**STAFF REPORT
FOR THE HISTORIC REVIEW BOARD**

FILE NUMBER: DR-11-12

REQUEST: New Garage Construction

The applicant is proposing to construct a garage in the side yard of the lot at 1769 4th Avenue. The garage would be accessed from 4th Avenue since there is not an alley on this side of the street. The project is subject to the approval criteria in CDC Chapter 25, Historic District.

STREET VIEW
SITE PLAN

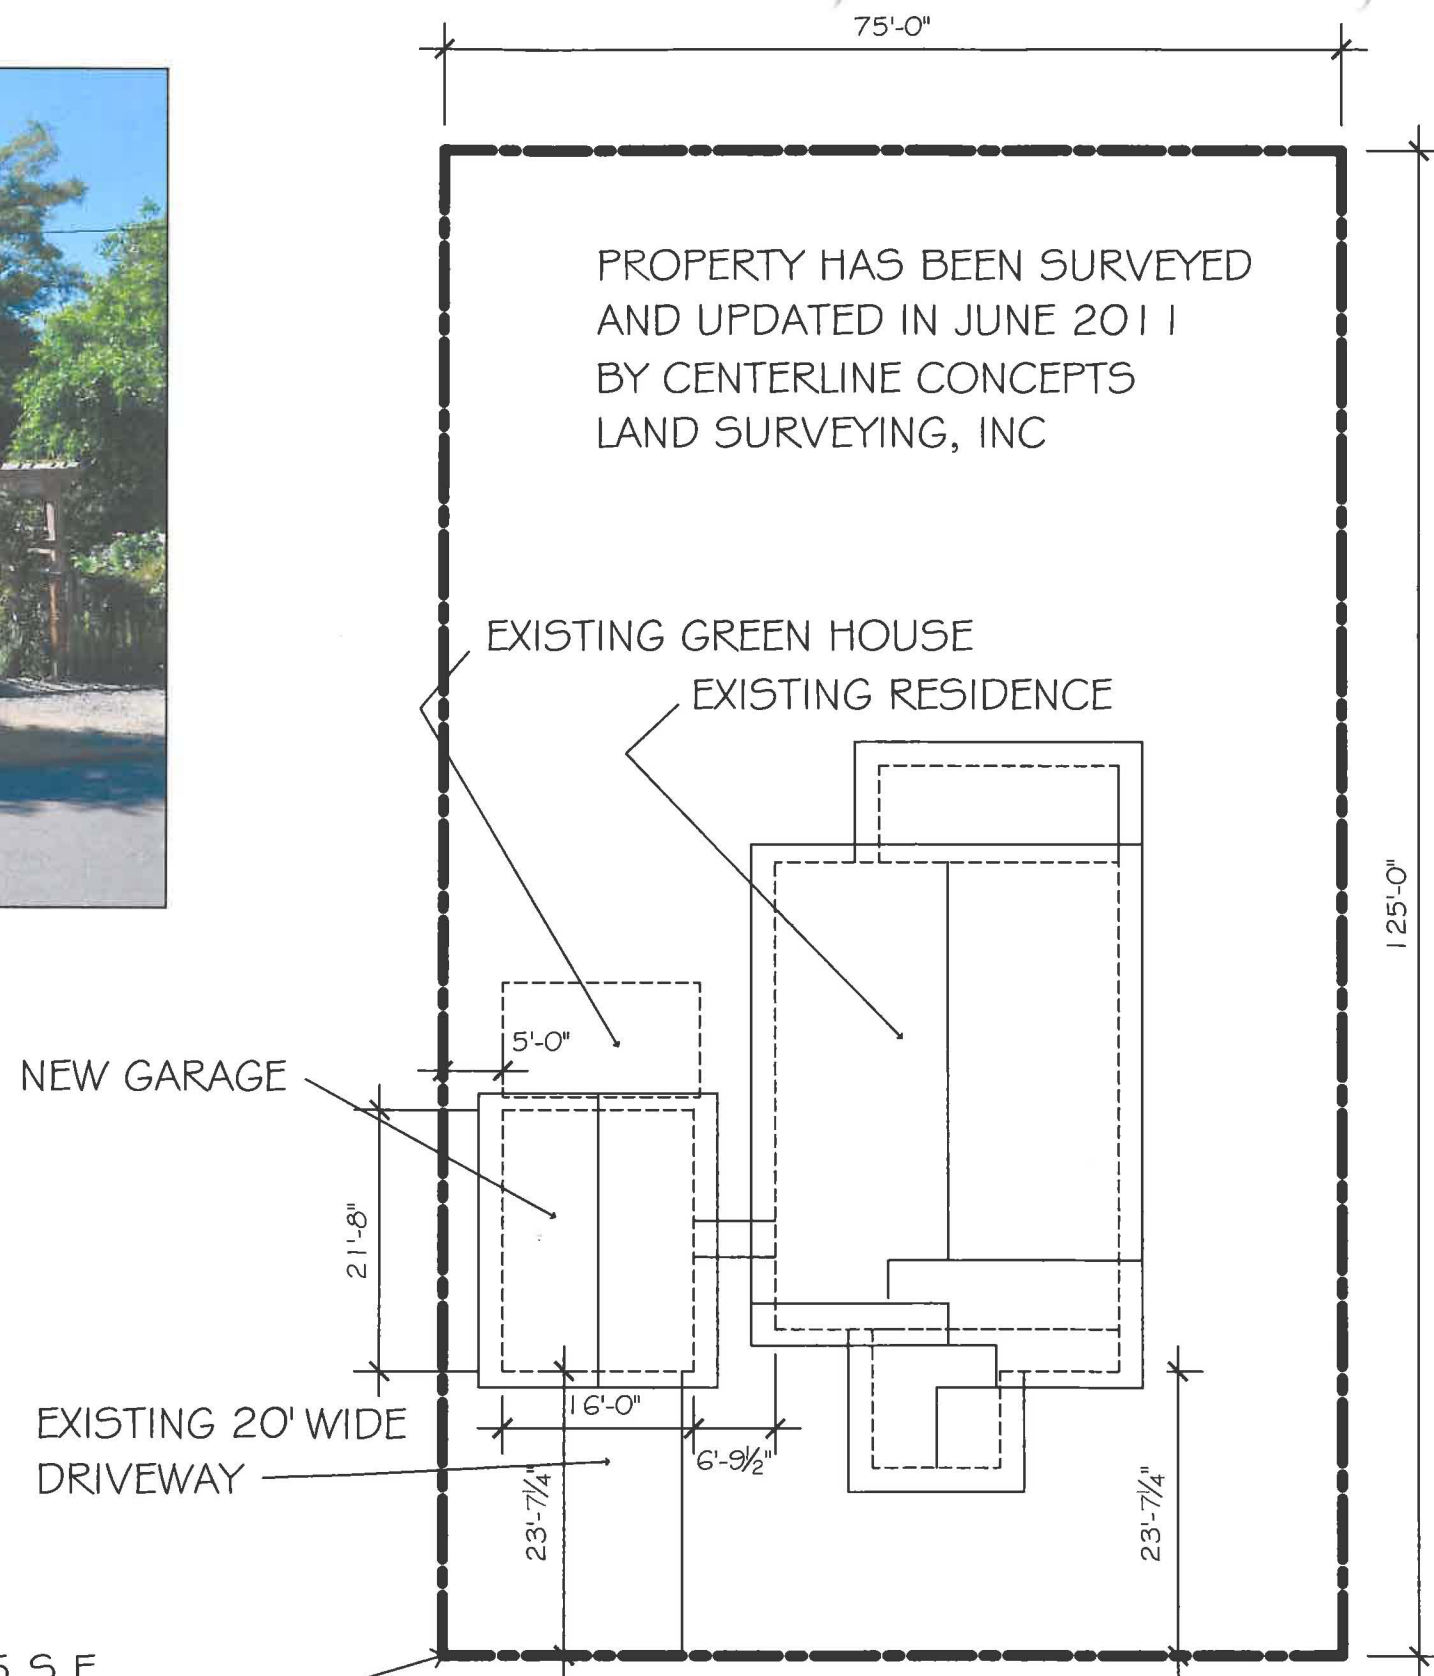
FINDING NO. 2: For #1, the front yard setback of the proposed garage is 23' 7 ¼", measured from the front property line to the dominant vertical face of the building. For #2, the side yard setback for the proposed garage is five feet, which is the required setback. Criterion 3 does not apply. For #4, the lot depth is 125' and the rear of the proposed structure will be approximately 75' from the rear lot line, far exceeding the 20' required. Criterion #5 does not apply. For #6, lot coverage, the total is approximately 20 percent, which is far less than the 50 percent permitted.

1. Site Plan and elevations. With the exception of modifications required by these conditions, the project shall conform to the plans labeled "Street View Site Plan" and "Sections Elevations Foundation Plan" in Exhibit HRB-3.
2. Windows. The windows on the west elevation shall be a pair of 2' x 3' fiberglass single hung windows as described in the applicant's narrative in Exhibit HRB-3. The window trim shall be at least four and one-half inches wide or the same as the original trim on the residence.

SECTIONS
 ELEVATIONS
 FOUNDATION PLAN

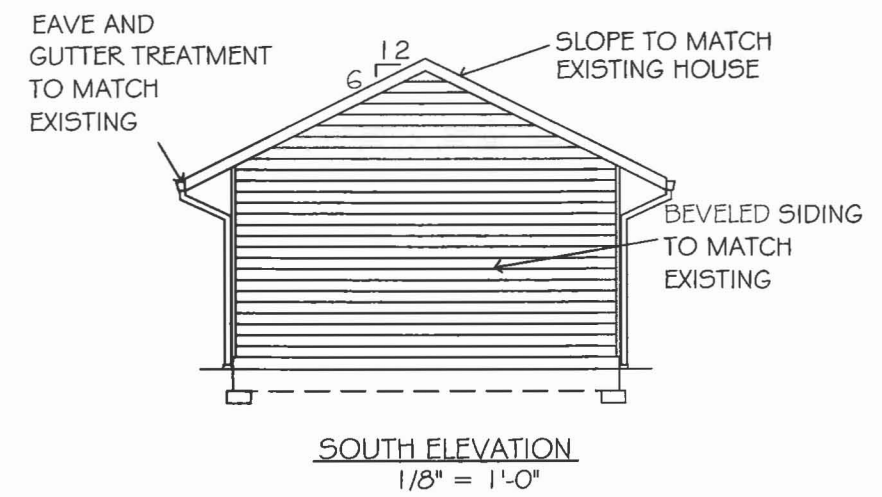
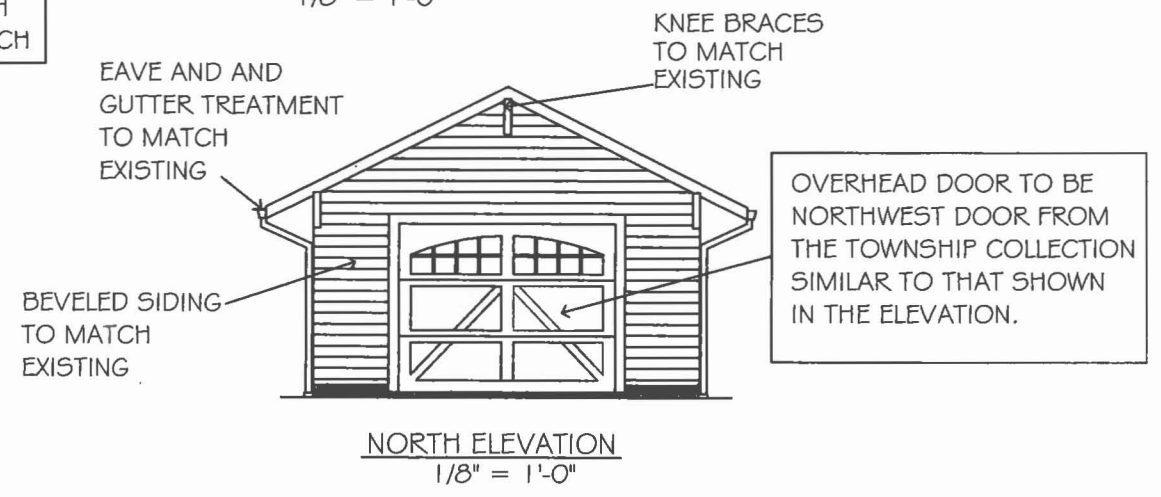
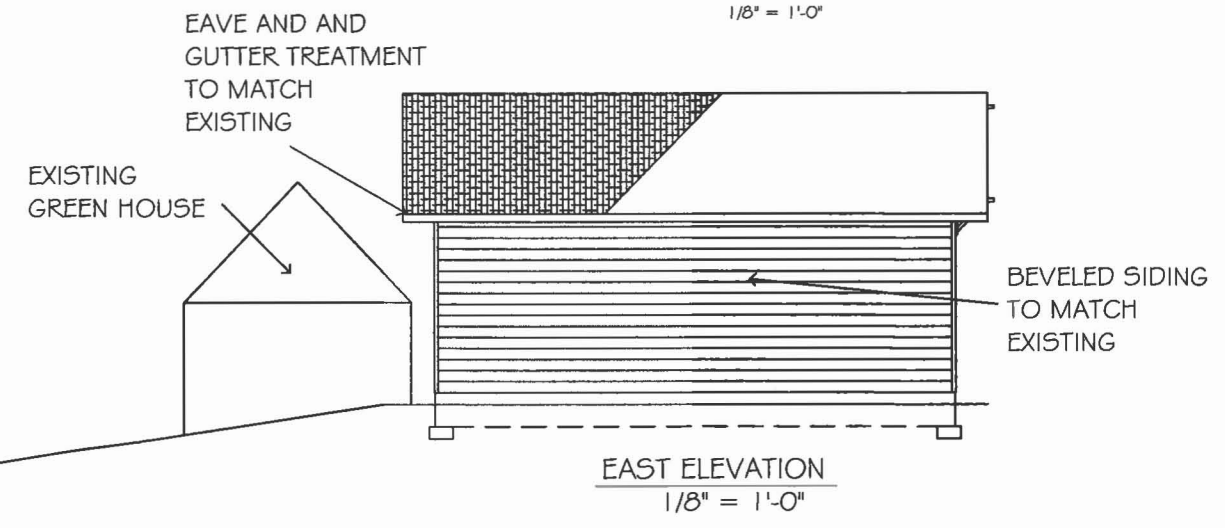
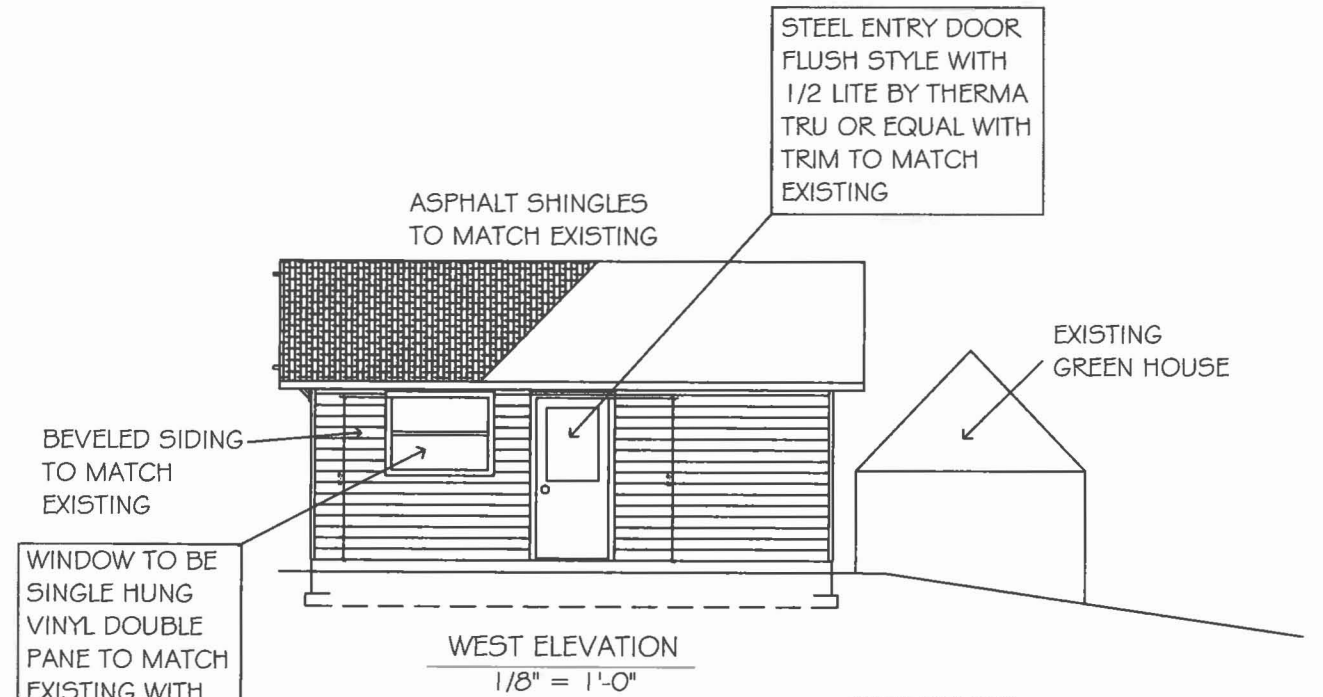
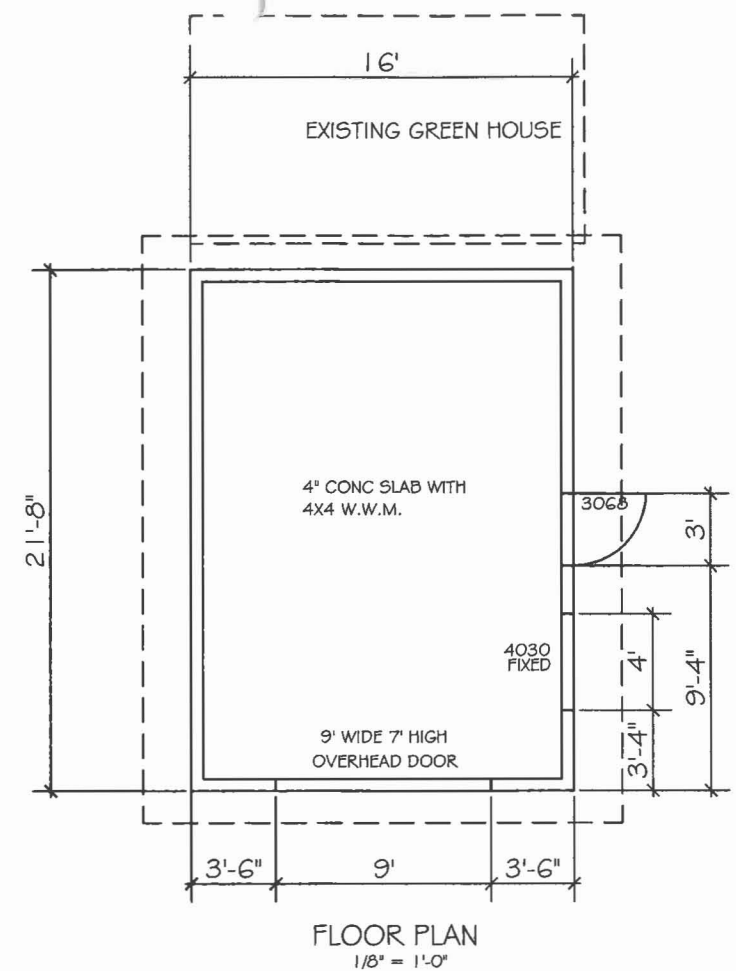
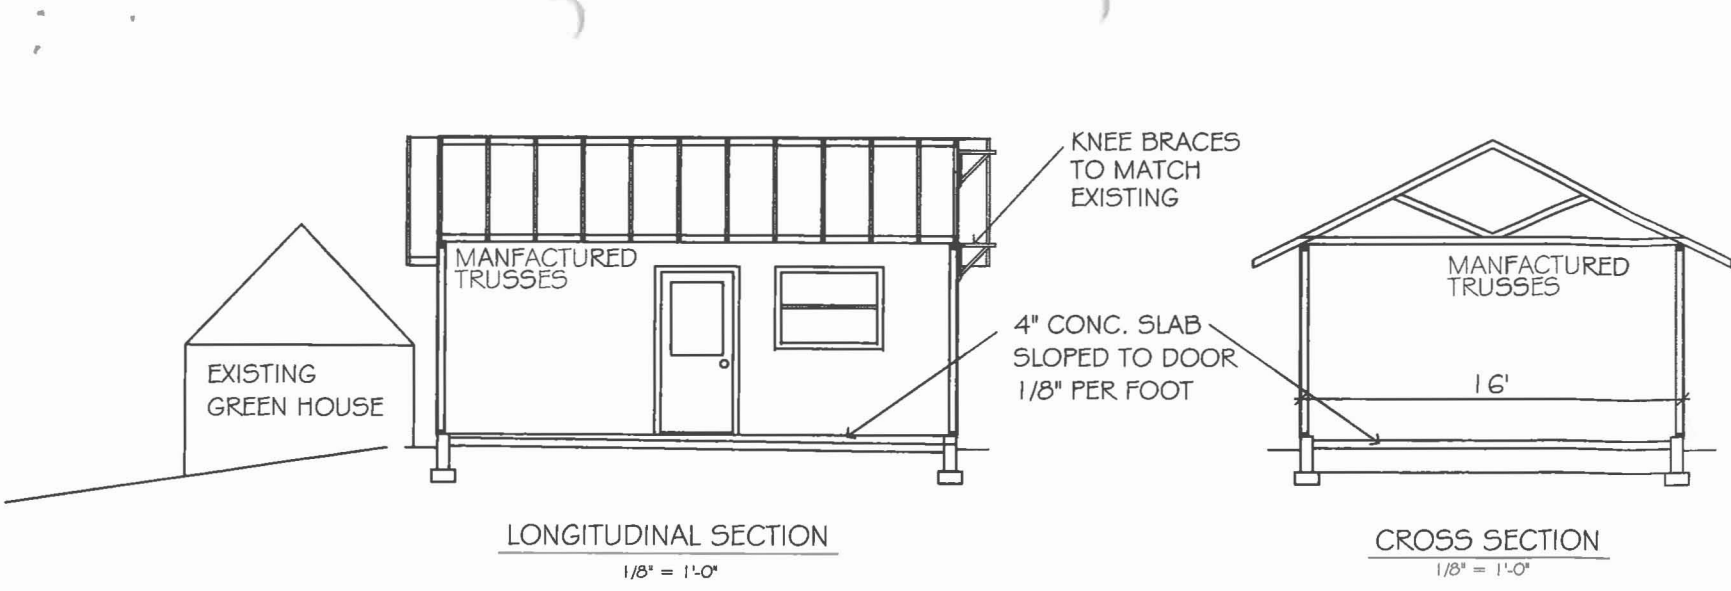
FINDING NO. 6: The applicant has agreed to install paired single hung 2' x 3' fiberglass windows on the west elevation. This is compatible with the massing, size, scale, and architectural features of the garage and primary residence. The trim is not identified and staff recommends a condition stating that the trim on the windows shall be at least four and one-half inches wide or match the original trim on the residence. Criteria 2, 4, and 5 do not apply. The applicable criteria are met.

FINDING NO. 7: There are two entries to the garage. On the north, or front, elevation is a carriage-style garage door that will be from Northwest Door's Township Collection. On the west, or side, elevation is a steel man door with a single light. The criteria are met.

The recommendation by Ms. Javoronok that the window be changed from what is drawn shall be followed. The new window in the West Elevation will be a Fiberglass 3030 single hung window which is more in keeping with windows on the house
